**CHARTER TOWNSHIP OF GARFIELD
PLANNING COMMISSION MEETING**

Charter Township of Garfield		General:	<input checked="" type="checkbox"/>
		Budget Related:	<input type="checkbox"/>
		In Camera:	<input type="checkbox"/>
Department:	Planning	Report No.	PD 2014-45
Prepared:	July 2, 2014	Pages:	1 of 5
Meeting:	July 9, 2014 Planning Commission	Attachments:	<input checked="" type="checkbox"/>
Subject:	Premier Manor – Major PUD Amendment – Initial Review		
File No.	SUP #2003 – 06 - D	Parcel No.	05-014-108-00
Applicant:	Mansfield Land Use Associates		
Owner:	Woodmere Crossing LLC

The Premier Place Planned Unit Development

The application proposes site plan and building design changes for the apartment area of the site. The application is considered a Major Amendment to the development, requiring review before the Planning Commission and eventual decision by the Township Board.

2014 Proposal

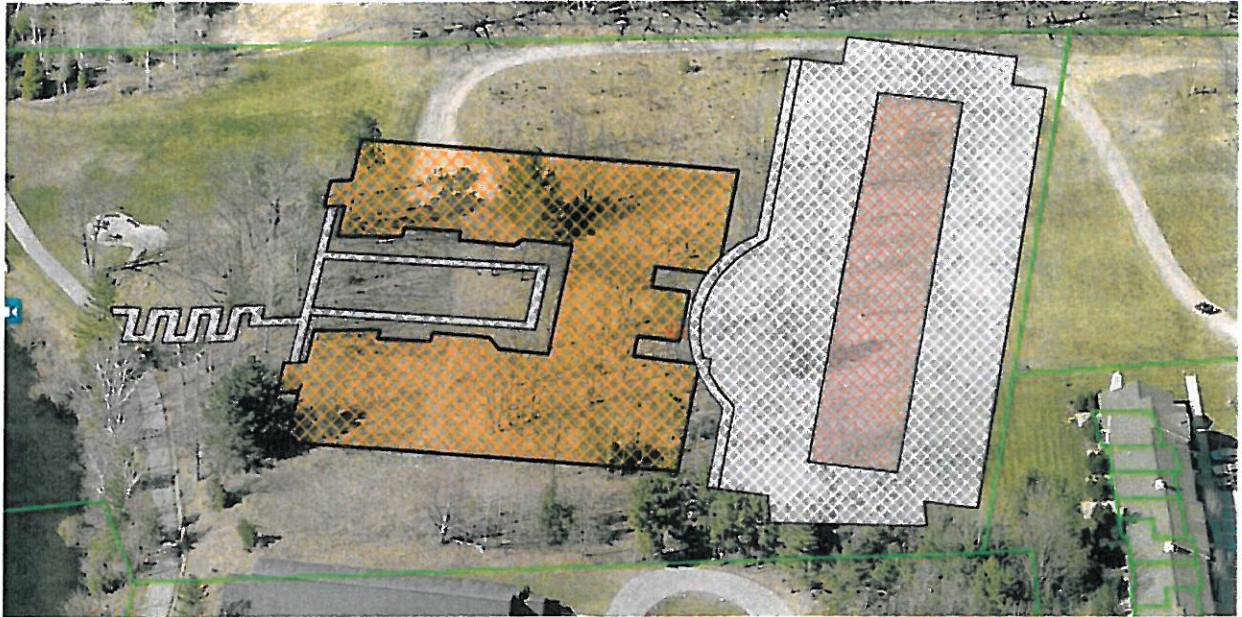
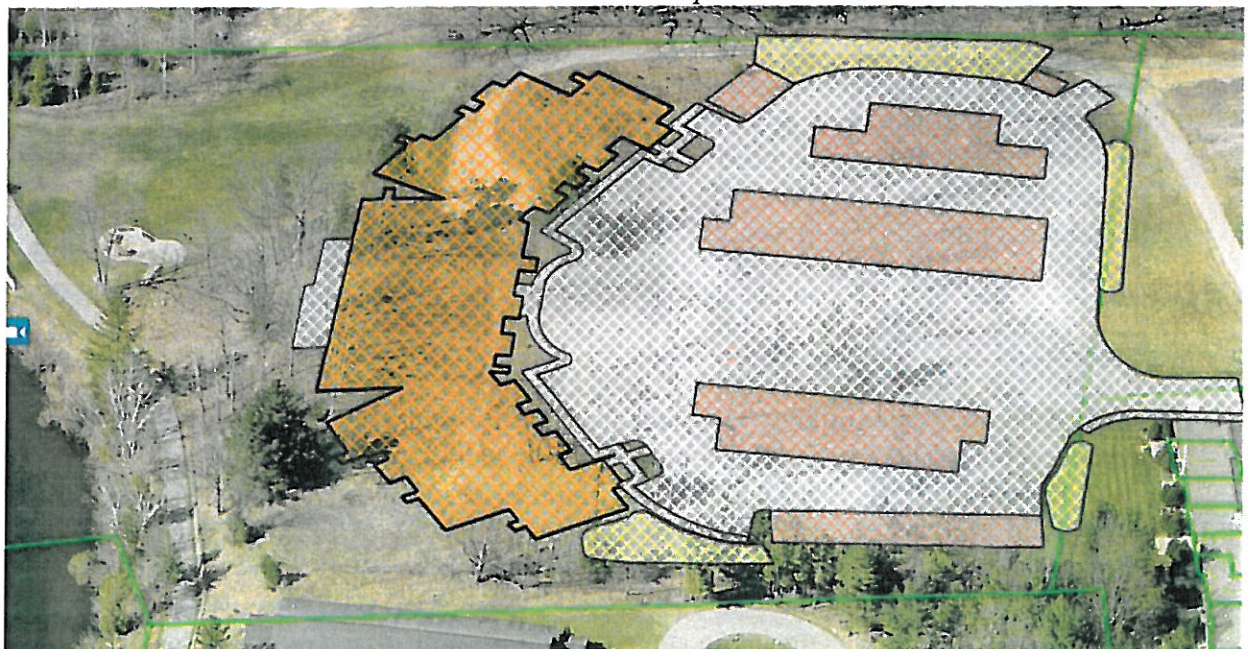
The current application proposes a complete redesign of Premier Manor. The building more closely follows the bluff leading down to Boardman Lake in an effort to provide more water-view units. The number of stories has been increased to four to allow the applicant to provide larger unit sizes but to keep the unit count at 72.

With an overall height of 45-feet to the top of the mansard-style roof (as measured from the front elevation), the proposed building would be about 20-feet taller than the neighboring structure to the south, Boardman Glen. The property to the north is within the City of Traverse City, and is planned for multi-family development with a height limitation of 40-feet. Because the building is a walkout (5 floors in total), the rear elevation (facing west) actually measures approximately 55-feet in height, with the basement elevation about 13-feet higher than the nearby bike trail. The architecture does reduce the outside 20-feet of building length to 3 stories.

The approved plan places the building about 90-feet away from Boardman Glen; the proposed building comes to about 55-feet from Boardman Glen. Both buildings come to about 60-feet from the Boardman Lake Trail.

The number of parking spaces has been increased from 64 spaces to 135 spaces (considering both exterior and garage spaces). The increase in impervious surface area was a discussion point when this application was last before the Planning Commission.

Connections with Street Network

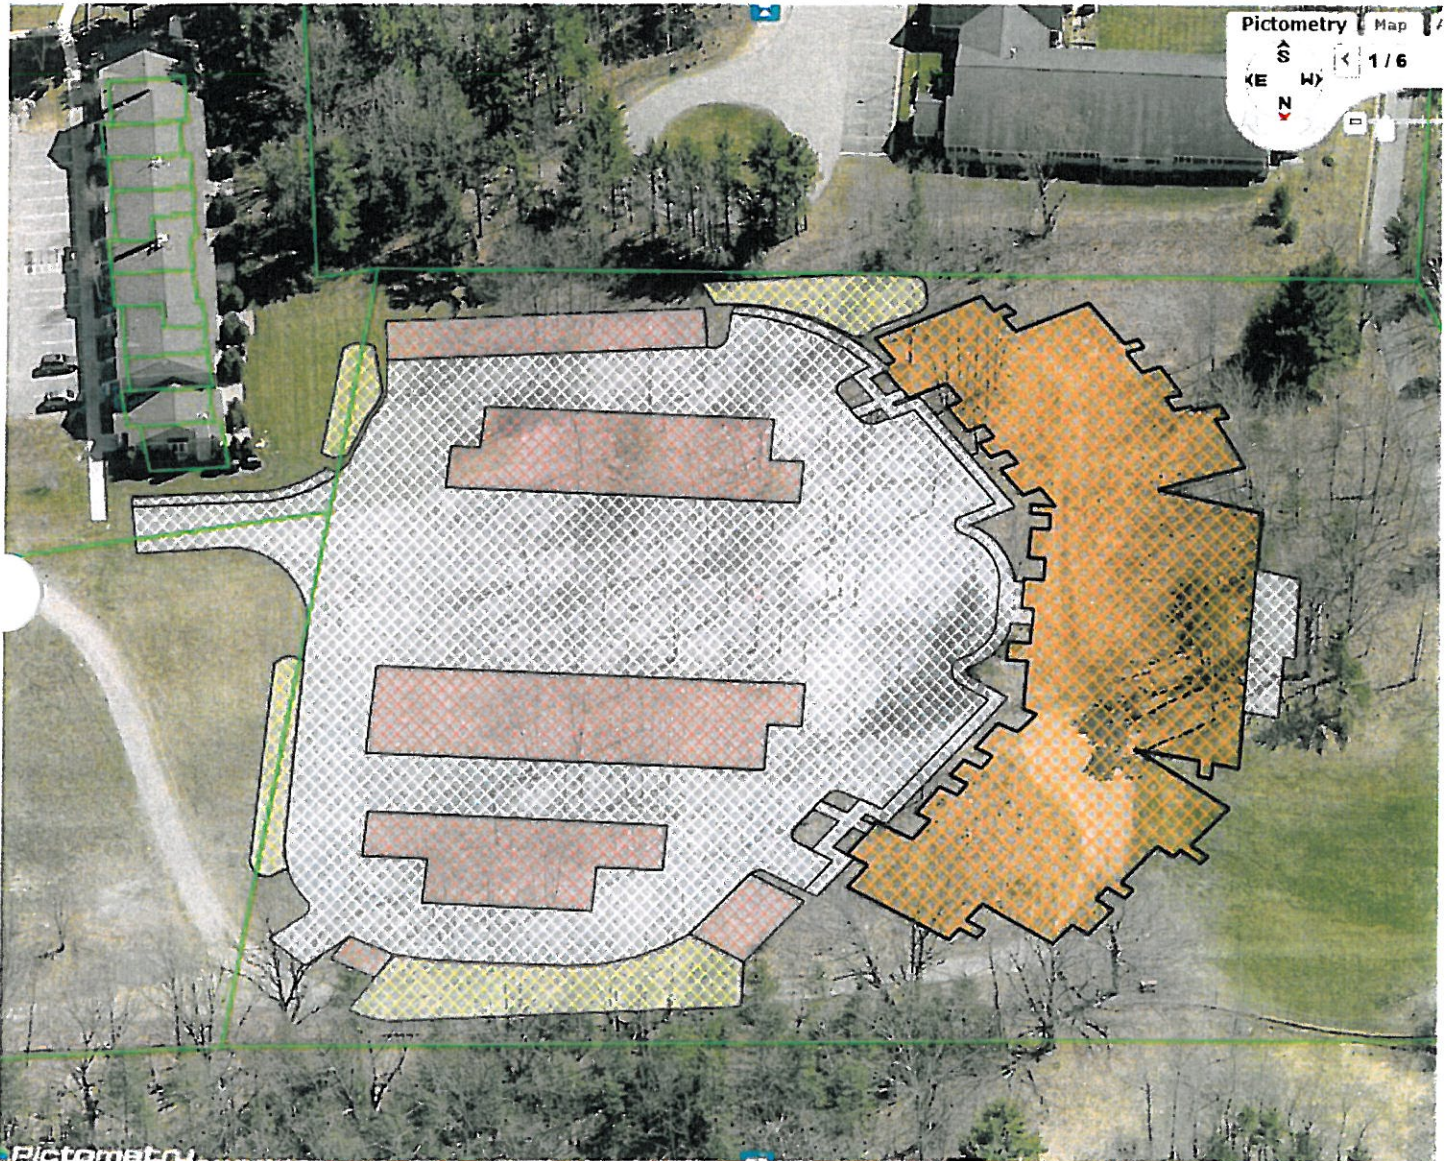
The applicant should speak to the redesigned entry from Woodmere Avenue, including the rail crossing for the line which runs parallel to Woodmere. A private crossing agreement has been provided for this crossing, subject to the owner paying a yearly \$1,000.00 license fee. The crossing agreement could be terminated by the railroad for failure to pay this license fee.

A traffic study prepared by the applicant has been provided; however a study prepared by an outside consultant has not yet been requested or provided.

PROJ. NO. 288412
 SHEET C-3

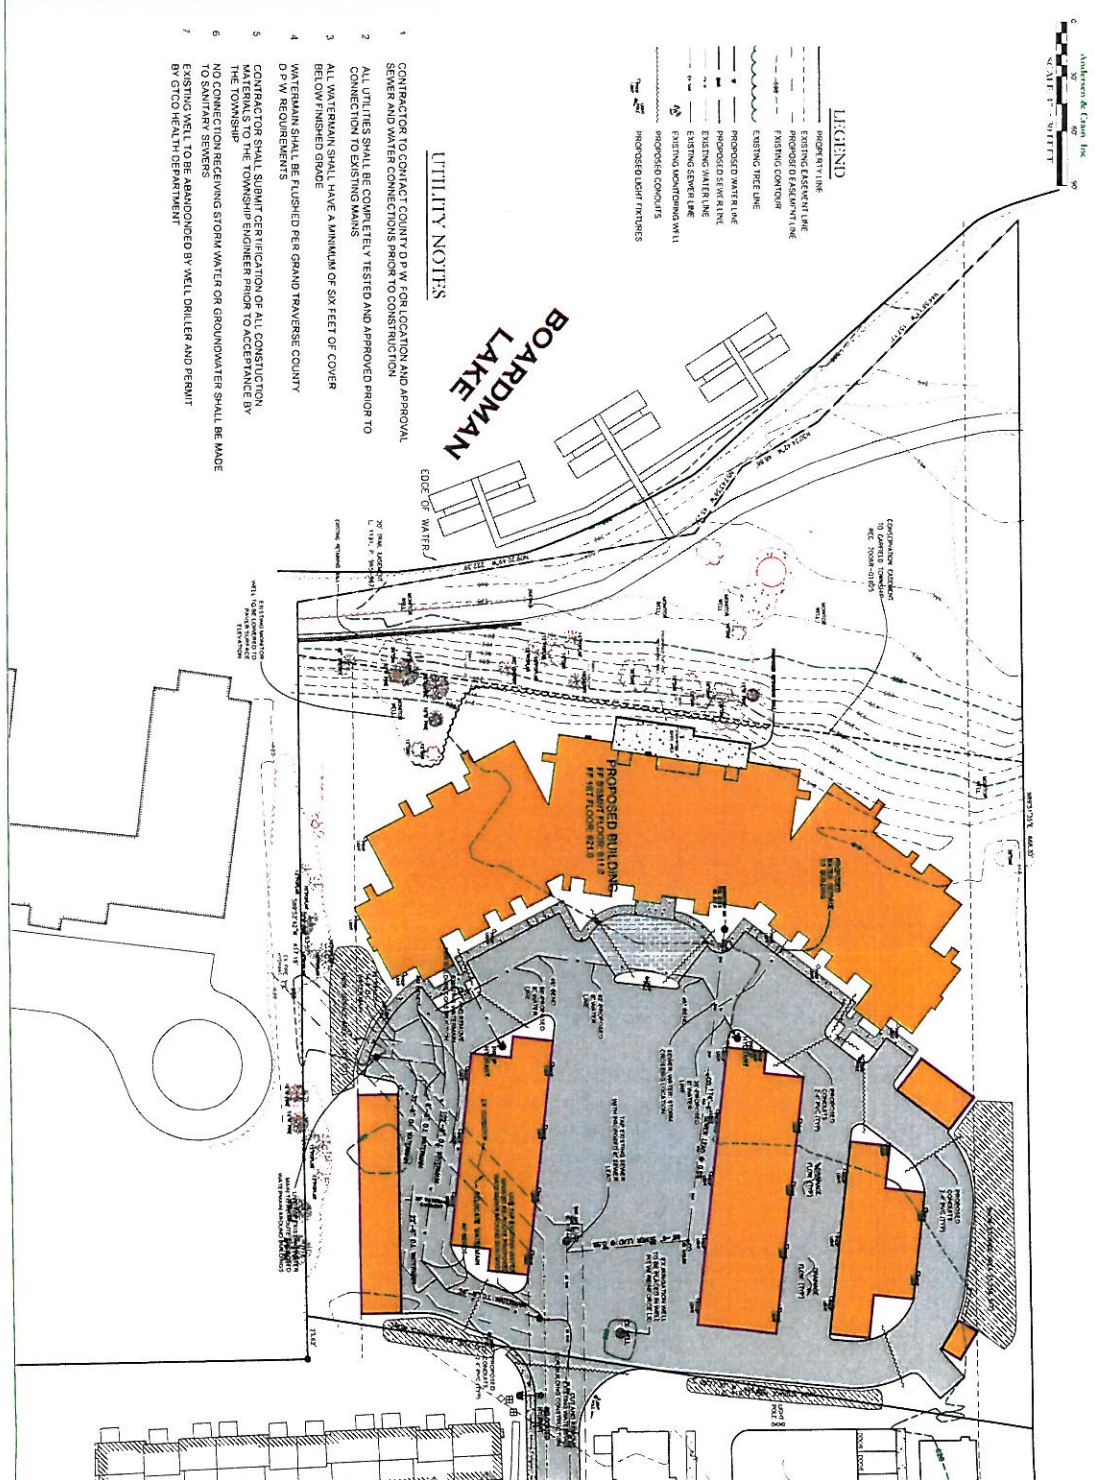
10. Note 7 on sheet C-3 indicates a well to be abandoned. Please indicate on the drawings which well this is.

Project Name: Premier Place

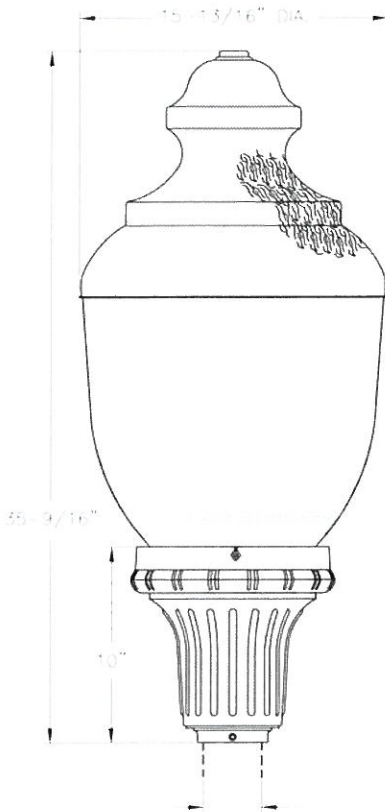
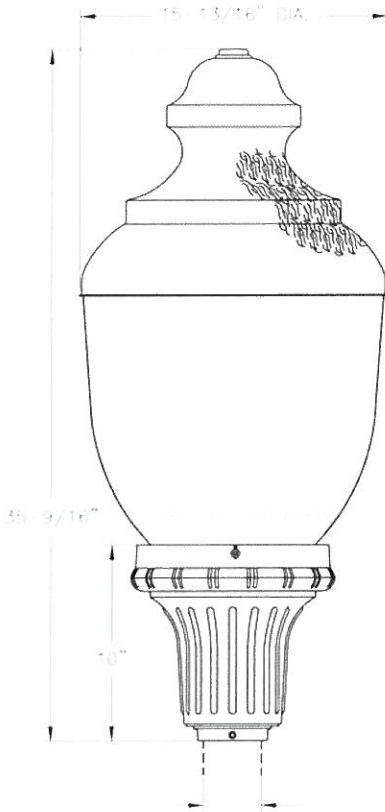
A lighting plan has been provided. Generally, levels are acceptable but will need to be adjusted at the east property line, where lighting levels exceed the 0.2 foot-candle limitation of the zoning ordinance. Fixture details have been provided but it is not clear if the "acorn" style light poles comply with full-cutoff restrictions.
